Access Compliance Report

Public Rights-of-Way

Intersection ID: 31352	Main Street: MCINTYRE_RIDGE_DR	Cross Street: TRULL_ST	Location: SE
ADA ID: A3B563D058BF	Ramp Type: BlendTrans1	Initial Pass/Fail: Fail	Overall Compliance: No
			Severity Score: 33.75

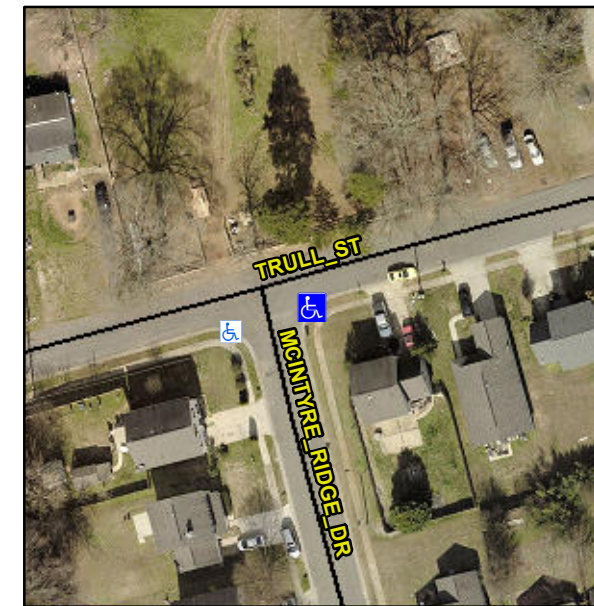
Not Found, R304.5.1, R304.5.3

Compliance	Description	Data	Compliance	Description	Data
N/A	Ramp Length (in)	43.5	Yes	BlendTrans Slope (%)	2.5
No	Ramp Width (in)	43.0	No	BlendTrans XSlope (%)	7.7
N/A	Flare Type LT	N/A	N/A	Flare Type RT	N/A
N/A	Flare Slope LT (%)	N/A	N/A	Flare Slope RT (%)	N/A
N/A	Flare Traversable LT?	N/A	N/A	Flare Traversable RT?	N/A
N/A	Landing Length (in)	N/A	N/A	DWS Provided?	N/A
N/A	Landing Width (in)	N/A	N/A	DWS Contrast?	N/A
N/A	Landing Slope (%)	N/A	N/A	DWS Length (in)	N/A
N/A	Landing X Slope (%)	N/A	N/A	DWS Full Width?	N/A
N/A	Landing Curb? (Y/N)	N/A	N/A	DWS Offset (in)	N/A
N/A	Shared Landing?	N/A			
N/A	Gutter Ponding?	N/A	N/A	Gutter Slope (%)	N/A
N/A	Gutter Lip Ht (in)	N/A	N/A	Gutter X Slope (%)	N/A
N/A	Painted X Walk1?	No	N/A	Painted X Walk2?	N/A
	X Walk 1 Direction	To W		X Walk 2 Direction	N/A
	X Walk 1 Width (in)	N/A		X Walk 2 Width (in)	N/A
	X Walk 1 Slope (%)	5.5		X Walk 2 Slope (%)	N/A
	X Walk 1 X Slope (%)	3.2		X Walk 2 X Slope (%)	N/A

N/A	Ramp inside XWalk1?	N/A	N/A	Ramp inside XWalk2?	N/A
	Road Slope (%)	3.2		Clear Space?	N/A
	Road X Slope (%)	5.5	N/A	Clear Space to XWalk (in)	N/A
N/A	Any Obstructions?	N/A	N/A	Storm Grate/Utility Hazard?	N/A
	Obstruction Type			Storm Grate/Utility Type	
		N/A			N/A
			Yes	Surface Condition? (G/P)	Good
			No	Curb Slope (%)	12.0

Remove & Replace Curb Ramp With Two New Directional Ramps or Equivalent.
